STAFF REPORT
(PRELIMINARY PLAT)

CASE NUMBER: SUB 2002-111 -- PEACOCK SECOND ADDITION

STAFF REPORT
(FINAL PLAT, PRELIMINARY PLAT APPROVED 10/31/02)

CASE NUMBER: SUB 2002-111 -- PEACOCK SECOND ADDITION

VICINITY MAP

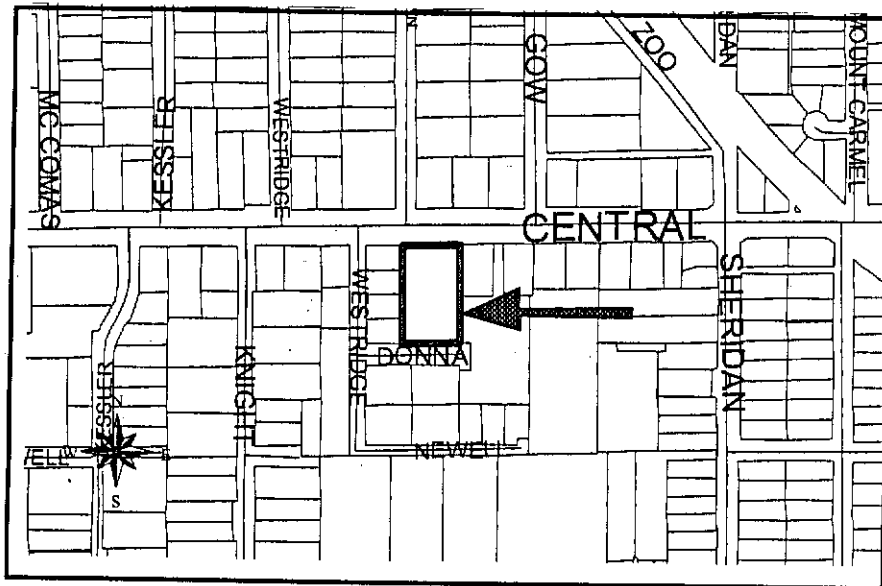
- A. Municipal services appear to be available to serve the site. **City Engineering** needs to comment on the need for guarantees or easements.
- B. If improvements are guaranteed by petition, a notarized certificate listing the petitions shall be submitted to the Planning Department for recording.

- C. **City Engineering** needs to comment on the status of the applicant's drainage concept.
- D. **Traffic Engineering** needs to comment on the access controls. The plat proposes one access opening along Central. The final plat shall reference the dedication of access controls in the plat's text. **Traffic Engineering has requested a restrictive covenant that permits future cross-lot access with the abutting property owner to the west along Central.**

- F. The plat's text shall include language that a drainage plan has been developed for the plat and that all drainage easements, rights-of-way, or reserves shall remain at established grades or as modified with the approval of the applicable City or County Engineer, and unobstructed to allow for the conveyance of stormwater.

VICINITY MAP

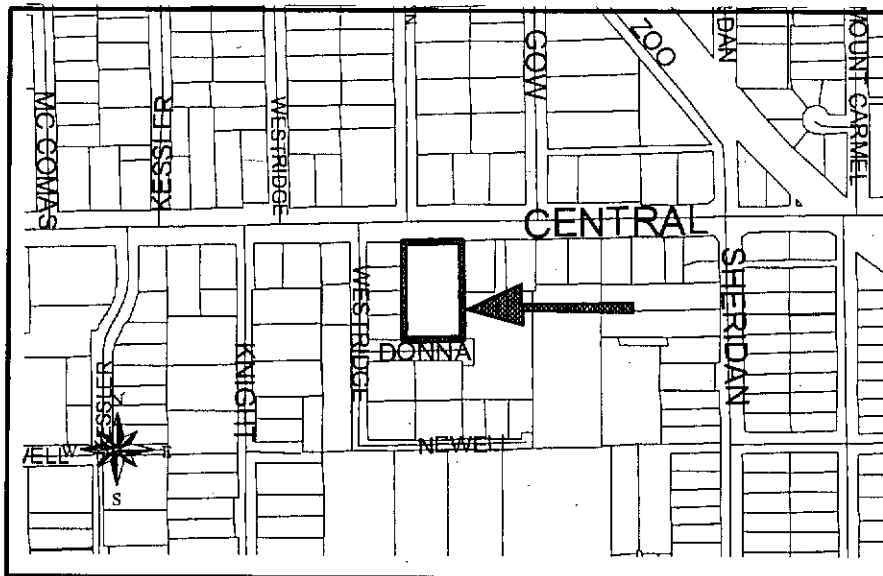
- A. Municipal services are available to serve the site. **City Engineering** needs to comment on the need for guarantees or easements. **A cross-lot drainage agreement is needed.**

- C. **City Engineering** needs to comment on the status of the applicant's drainage plan.
- D. The plat proposes one access opening along Central. **Traffic Engineering has approved one opening in alignment with Joann Street which is a deviation from Access Management Regulations. A memorandum has been provided to MAPC in this regard. A cross-lot access agreement needs to be provided between the two lots. A restrictive covenant is also requested that permits future cross-lot access with the abutting property owner to the west along Central.**

- E. The applicant shall guarantee the closure of any driveway openings located in areas of complete access control or that exceed the number of allowed openings. **The applicant will submit a Driveway Closure Certificate in lieu of a guarantee as the driveway will be closed upon site development.**

- F. **City Engineering** has requested a No Protest Petition to pave Donna Avenue.
- G. The plat's text shall include language that a drainage plan has been developed for the plat and that all drainage easements, rights-of-way, or reserves shall remain at established grades or as modified with the approval of the applicable City or County Engineer, and unobstructed to allow for the conveyance of stormwater.
